RE: **Volcano Cliffs Subdivision Lot 37 Block 8 Unit 22**

~~6427~~ **6431 Picardia Pl NW**

Grading and Drainage Plan

Engineers Stamp Date 2/9/15 (D10D003E37)

PREPARED BY STEVEN J. METRO, PE AND PS
GRADING & DRAINAGE PLAN
~~6431~~ ⁶⁴²⁷ Picardia Place NW
 LOTS 37, BLOCK 8, UNIT 22 VCS

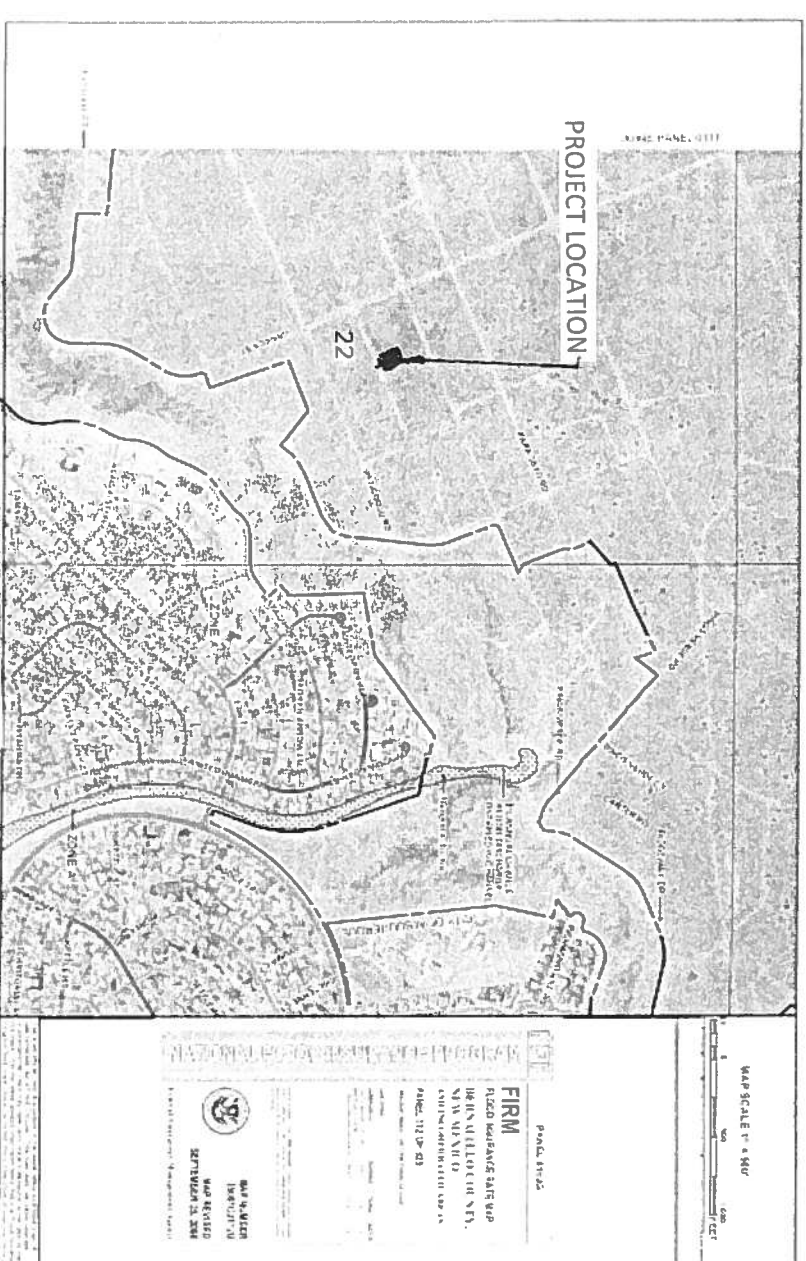
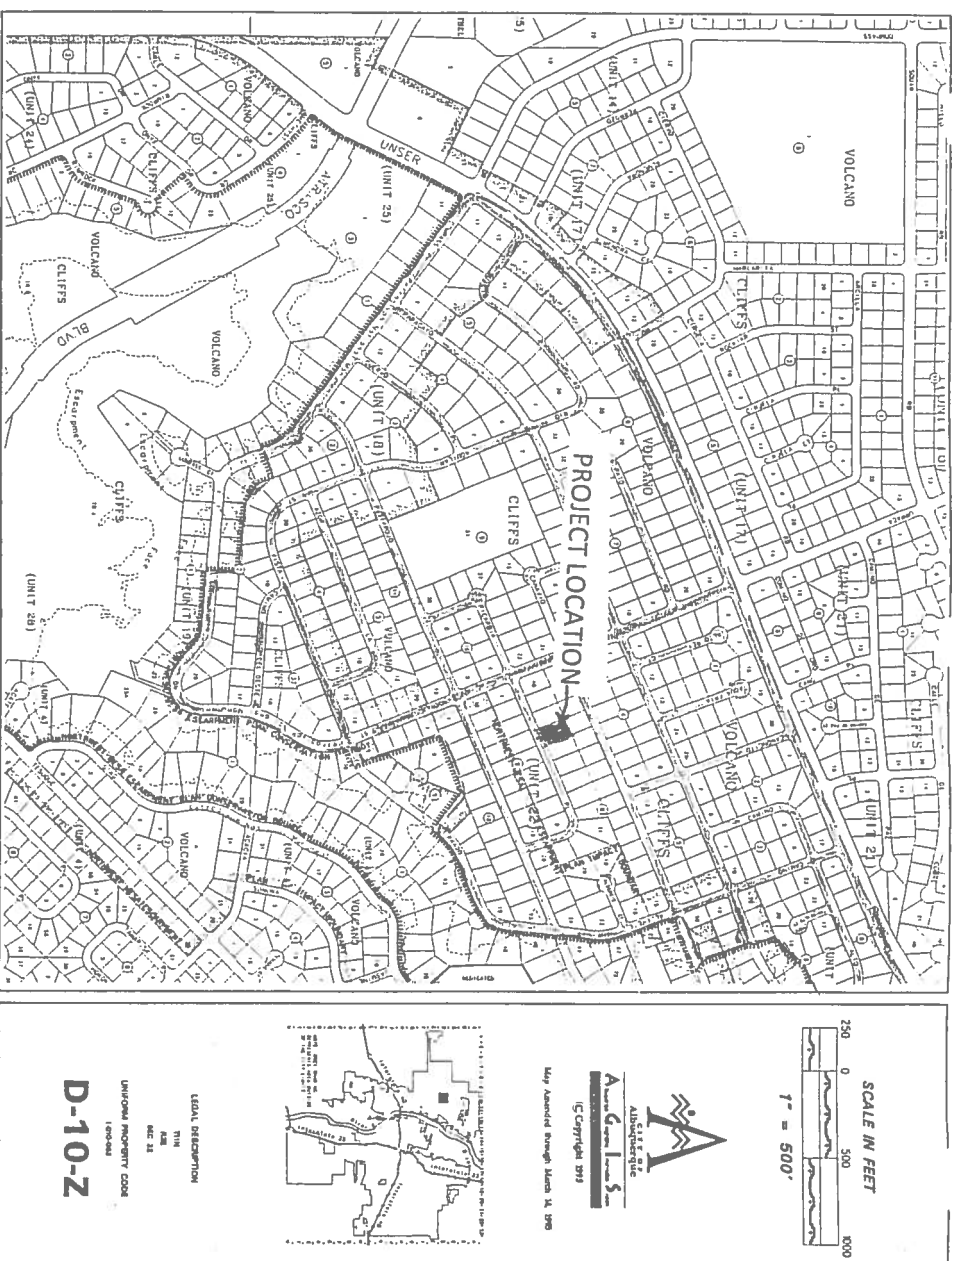
Based upon the information provided in your submittal received 4/9/15, this plan is approved for Grading Permit and Building Permit.

Please attach a copy of this approved plan to the construction sets in the permitting process prior to sign-off by Hydrology.

Prior to Certificate of Occupancy release, Engineer Certification per the DPM checklist will be required.
